UNITED STATES PATENT AND TRADEMARK OFFICE

APPLICATION NO.	FILING DATE	FIRST NAMED INVENTOR	ATTORNEY DOCKET NO.	CONFIRMATION NO.
10/693,005	10/24/2003	John W. Forsberg	1023-294US01	9349
28863	7590	06/01/2006	EXAMINER	
SHUMAKER & SIEFFERT, P. A. 8425 SEASONS PARKWAY SUITE 105 ST. PAUL, MN 55125			FLORY, CHRISTOPHER A	
			ART UNIT	PAPER NUMBER
			3762

Office Action Summary

DETAILED ACTION

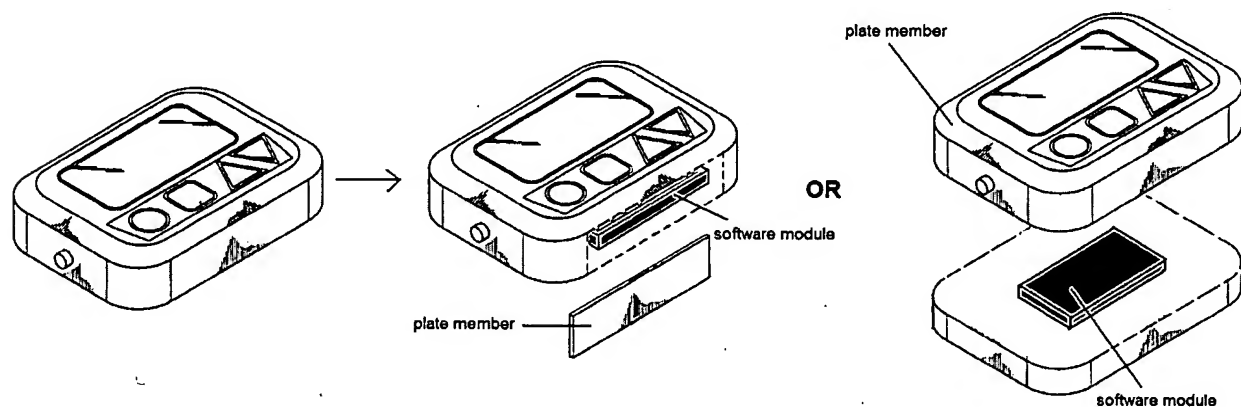
Regarding claims 6 and 8, the device of Meadows et al. is shown in Fig. 5 to be constructed of a housing with more than one part (Fig. 5, column 36, line 46 discloses an upper housing). Any electronic device comprising housing of more than one part and containing software loaded on a memory inherently comprises a software loading port, where the port is considered to be the open portion of the housing in which the software-loaded circuitry is being inserted or affixed, and the other portion of the housing is considered to be the plate member covering the loading port.

Regarding claim 9, Meadows et al. discloses that the plate member be printed with identifying information (column 38, line 55 through column 39, line 15). Given the configuration shown on the right side of the figure above, the disclosed labels on the buttons clearly satisfy this claim limitation.

Furthermore, having a battery bay that extends into an aperture defined by the antenna is almost inherent in the nature of a device small enough to be held in the hand (the figure provided above with a battery in place of the memory module provides a good example of this). Still further, the aperture as claimed could be defined as the housing of HHP 202, of which the battery bay is an inherently integral and internal part.
